Annex C

Details of Proposals

Location: The Hollies, Stockton on the Forest

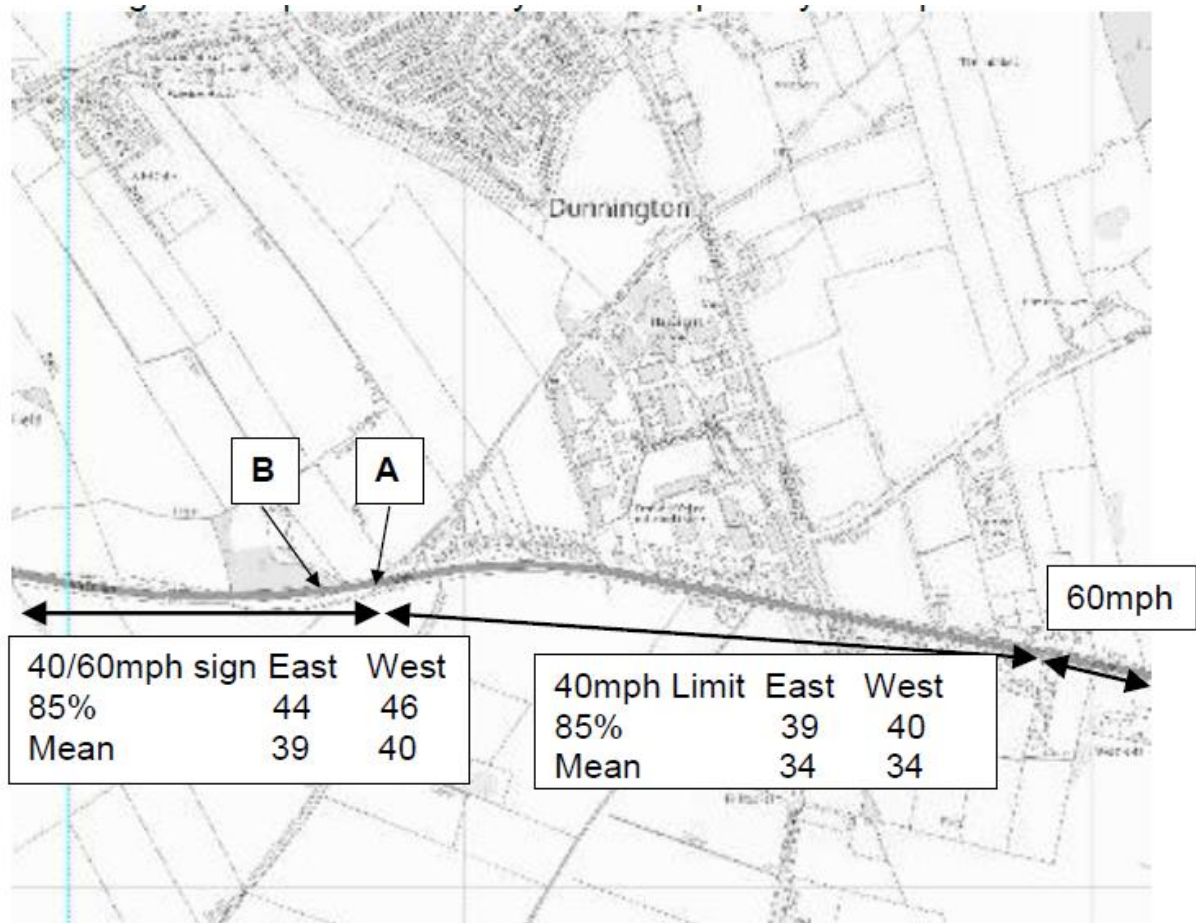
Supportive of the extension of the 20mph speed limit to The Hollies which obviously avoids a ridiculous situation where the Hollies has a

higher limit than the adjoining section of The Village -- however your proposal mentions "introduction of the respective speed limit with associated signage" - can you give more details on this signage and its location in the street? (Has been provided).

Police Comments: No issues.

Officer Comments: Implement as advertised: An appropriate approach in the circumstances.

Location: A1079 Dunnington

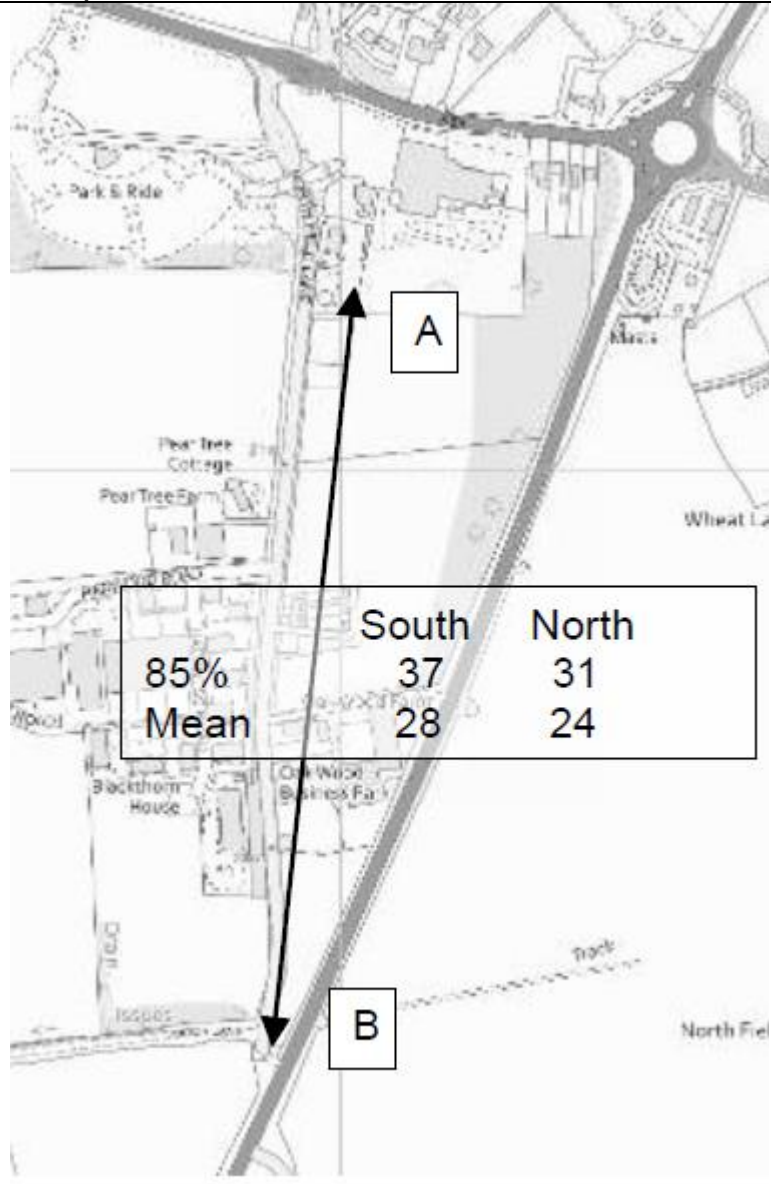
I wish to object to the proposed speed limit reduction on the A1079. A reduction to 40mph on this short section of Highway is not what was requested by Dunnington PC or Kexby PC. Requests have been made for a continuous 40mph speed limit along the full length of the CYC section of the A1079 in effect linking the existing 40mph zones at Dunnington with those at Kexby. Those requests have been made not only with regard to road safety but to give drivers a clear and

The Parish Council requests that the City of York Council progress with reducing the speed limit from 60 mph to 40 mph along the two sections of the A1079 from the Scrap Box layby (point A) to Thornbeck (point B) and the village boundary of Dunnington (point C) to the village boundary of Kexby (point D). (See the attached map)

Police Comments: We would not support the extension of the 40 limit. It doesn't meet the DfT criteria, it's not clear where the speed data was collected and the existing 40 appears to work well as it is. There is no history of RTC's at the north end of the existing 40mph limit.

CYC Highways Engineer Comments: Agrees with Police comment.

Officer Comments: Implement as advertised under an Experimental Traffic Order for a period of 18 months and gather live data. The representations made concern a wider extent of speed limit reduction, which can be kept under review but should not affect the implementation of this section.

Location: Northfield Lane Upper Poppleton

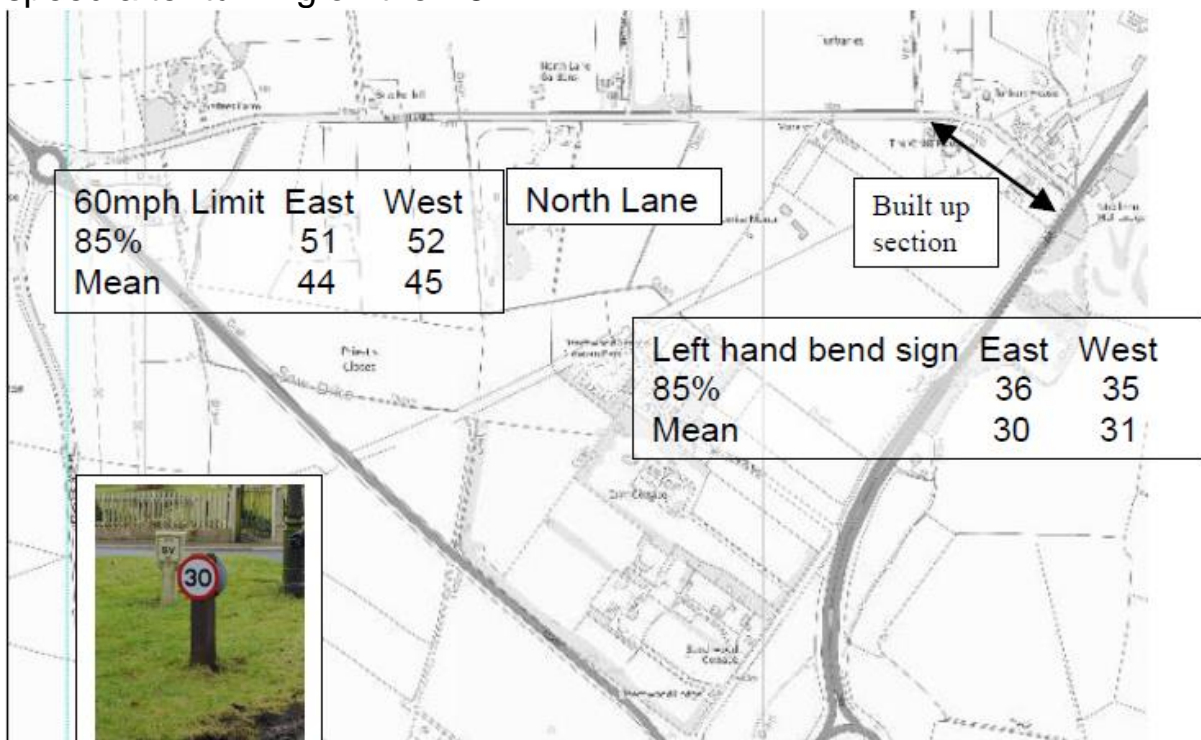
You might have seen the press release which shows how pleased I am with the possible introduction of a 30mph limit in Northfield Lane (which I have been requesting for a long time).

Police Comments: North Field Lane, we would support a 40mph limit for the entire length however the road is not appropriate for a Quiet Lane as it is the access route to two industrial estates and not suited to the mixed use that a Quiet Lane is intended to encourage.

CYC Highways Engineer Comments: 85th %ile speeds not in line with a 30mph limit - 40mph?

Officer Comments: Implement as advertised. The Implementation will help encourage safe use of the recently introduced cycle and walking path.

Location: North Lane, Huntington

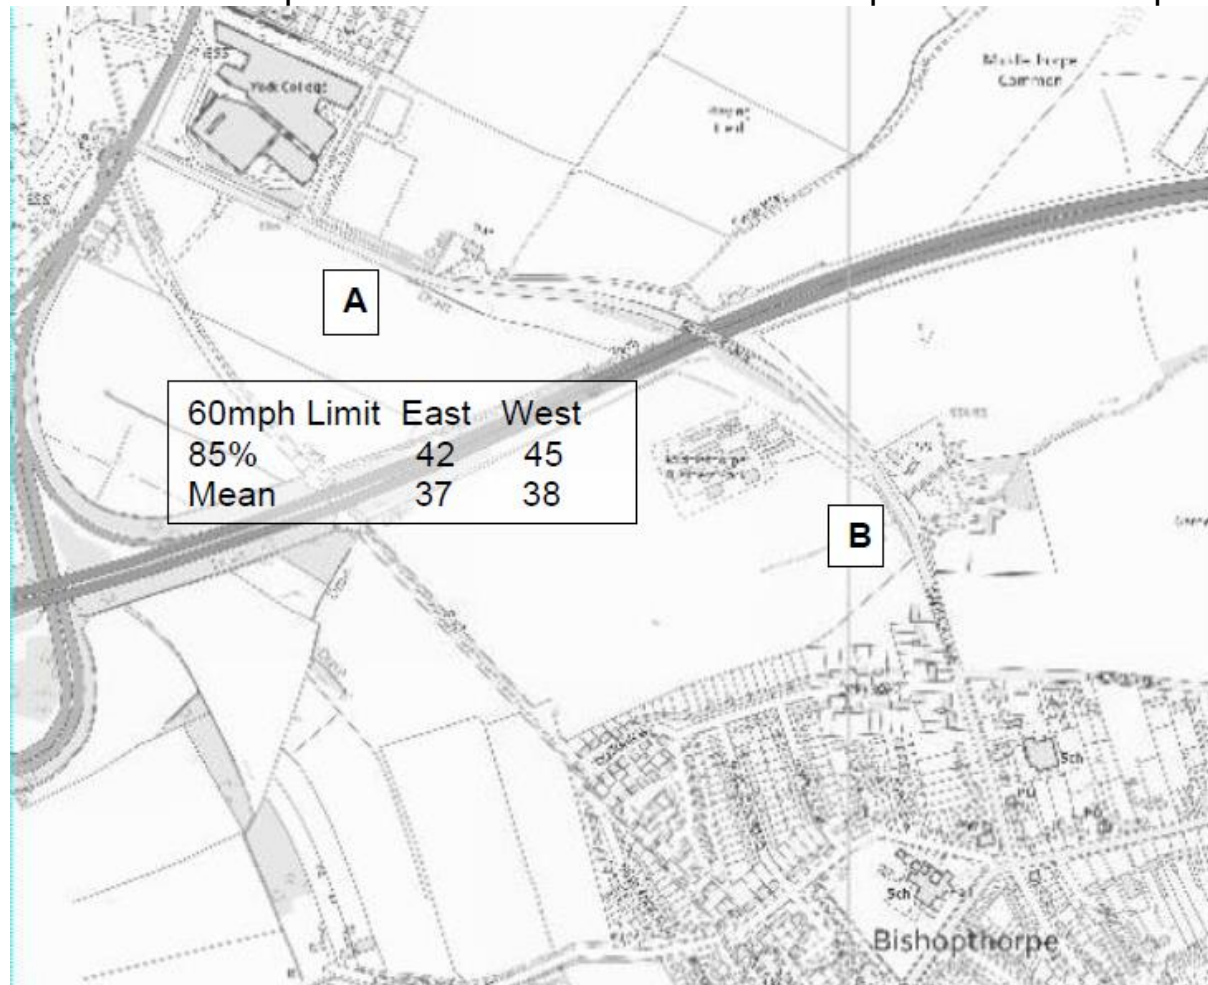
Many thanks for the letter explaining the proposed introduction of the speed limit. I welcome this new speed limit as cars do speed down this road on a regular basis. However, my questions that I would like responding to are:

- how is this going to be managed as no-one takes notice of the 40mph limit at the top end currently - in fact the sign is completely hidden by overgrown bushes and has been for several years!!!
- there is currently a 7.5T limit on the road - however lorries, wagons and

Thank you for the notice regarding the 30mph speed limit proposal on North Lane which I support completely. Living on the bend we have had accidents and near misses with drivers coming round too fast and this will make the lane safer for all.

CYC Highways Engineer Comments: Unclear where the speed data was collected, but not in line with a 30mph limit. Likely to be an enforcement problem and reported back via speed concerns. Proposed 30mph is very short, minimum length recommended in Setting Local Speed Limits is 600m.

Officer Comments: Implement as advertised. The responses indicate the level of impact for local residents and implementation will make this a safer location for their access onto and from North Lane.

Location: Askham Bryan – 2 sites

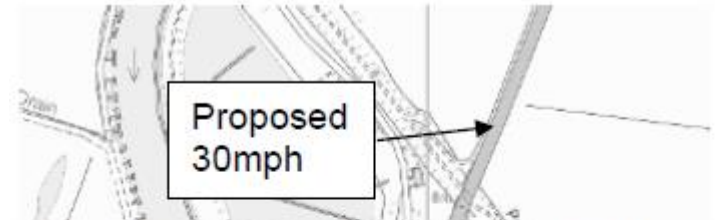
Site 1. We would support an extension to the 30mph limit however it would work better if the new limit started at a point where the change in environment was clearly visible which appears to be about 90m from the current 30mph limit.

Site 2. There is a system of carriageway lights on the A1237 and the area around the roundabout and the Copmanthorpe intersection, as well as past the college, which all need to be resolved. We would support the introduction of a 40mph limit from the roundabout to a point approximately

350m from the roundabout, which combined with the reduced speeds on the A1237 roundabout could be expected to work. We would not support the introduction of a 30mph limit between the two limits as this does not meet the DfT criteria and speeds are not commensurate with a 30mph limit. We would support a short extension of the existing 30mph limit to cover the access to the play area.

CYC Highways Engineer Comments: Need speed data before making any firm comments. Site 1 - seems ok, but needs speed data to confirm. Site 2 - For Info - National Highways are looking at scheme at the roundabout to reduce queuing on the A64 Eastbound slip. No issue with the extension for the play area or 30mph from the roundabout past the college. 40mph would need to see speed data.

Officer Comments: Implement as recommended at Site 1 which will provide a 'buffer' area prior to the built-up area allowing a greater prospect of traffic reducing speed prior to reaching it.

Implement the extension of the 30mph from the Village as advertised at at Site 2 as this will allow traffic to sufficiently reduce speed prior to the area by the playpark and residences. Implement a lesser restriction of 40mph to the beginning of the Street Lighting and correctly sign the 30mph from that location to the A64/A1237. As stated by some objectors, there is street lighting which would indicate a Statutory 30mph speed limit, but it appears that this has not previously been signed correctly.

Location: Naburn

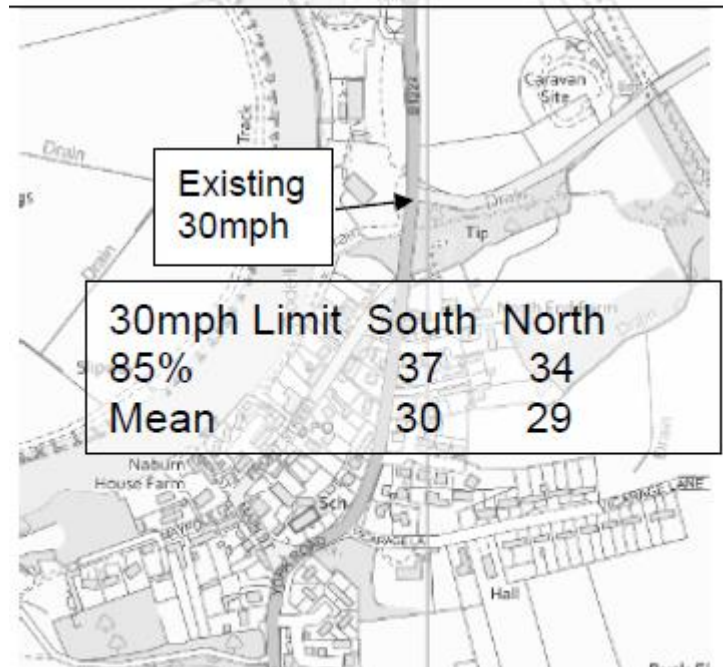
Naburn Parish Council very strongly supports this scheme and thanks you for getting it through.

Police Comments: We would not support the extension to the 30mph limit,

the speeds are some way from being commensurate with a 30mph limit and the road does not meet the DfT criteria. The recorded speeds southbound in the existing 30mph are high and this reinforces the opinion that an extension to the existing 30mph is unlikely to work without long term enforcement. We have previously supported the introduction of a 40mph limit on this section of work which would be appropriate.

CYC Highways Engineer Comments: Drivers are not obeying the existing 30mph limit, no reason to suspect they will obey the proposed one. 85th%ile speeds in the 60mph confirm that. 40mph instead??

Officer Comments: Implement as advertised. There is no footpath in the area of recommendation meaning users leaving the York/Selby foot/cycle way have to use the road. There have also been cycle scheme improvements in this area that further support a reduced limit. The dip under the bridge is a feature that generally results in traffic slowing at this location and implementation will help protect those in residence and those visiting the marina whether on foot or in vehicles.

Location: Towthorpe

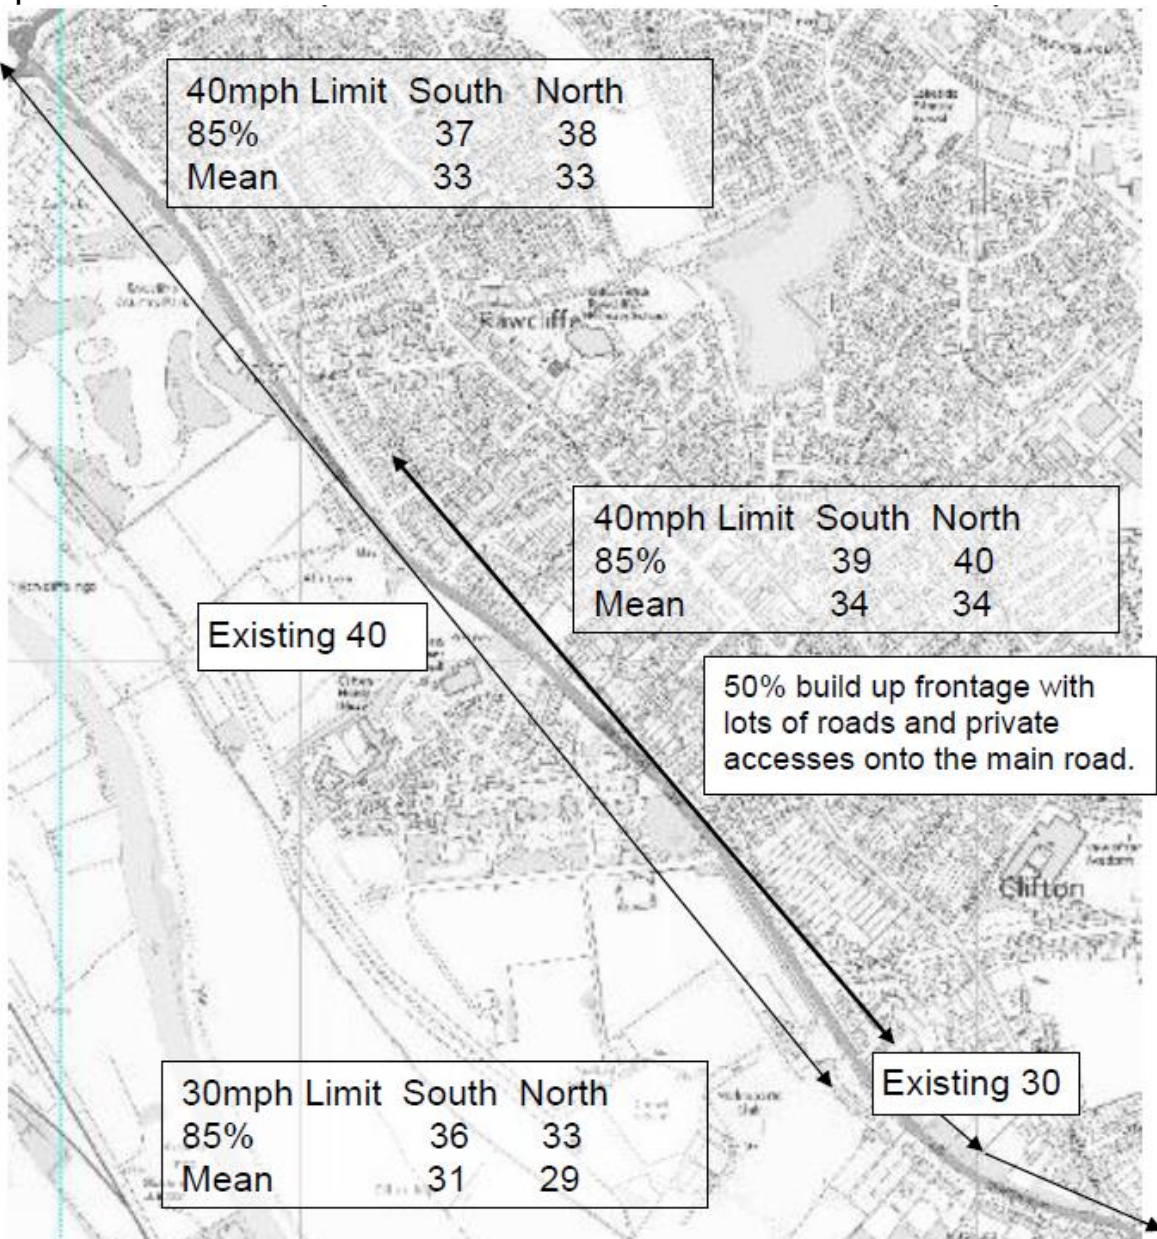
1. I support the proposal on the grounds of road safety and amenity.
2. I request that the review should extend further along the length of Towthorpe Road as far as the boundary with Haxby. The proposed amendment leaves this section of Towthorpe Road as derestricted (60mph) and I request that this is also reduced, to either 30mph or 40mph. My own observations indicate that the 85th percentile speed of this section of Towthorpe Road is around 40mph. The rationale for this request is that:

Police Comments: We would not support the introduction of a 30mph speed limit. The developments associated with the conversion of farm buildings are isolated from the village, the road does not meet the criteria for a 30mph speed limit and there is no speed data attached. There is an existing footway and the only recorded RTC was a motorcyclist who fell off at low speed on the bend.

CYC Highways Engineer Comments: No data to indicate whether this is suitable. Quick check on streetview suggests not - 40mph, if data agrees.

Officer Comments: Implement as advertised under an Experimental Traffic Order for a period of 18 months and gather live data. This short section of village road has seen increasing use as mentioned above, and by its nature of road layout and residences/population along it is deserving of a reduced speed limit which is likely to be observed and complied with.
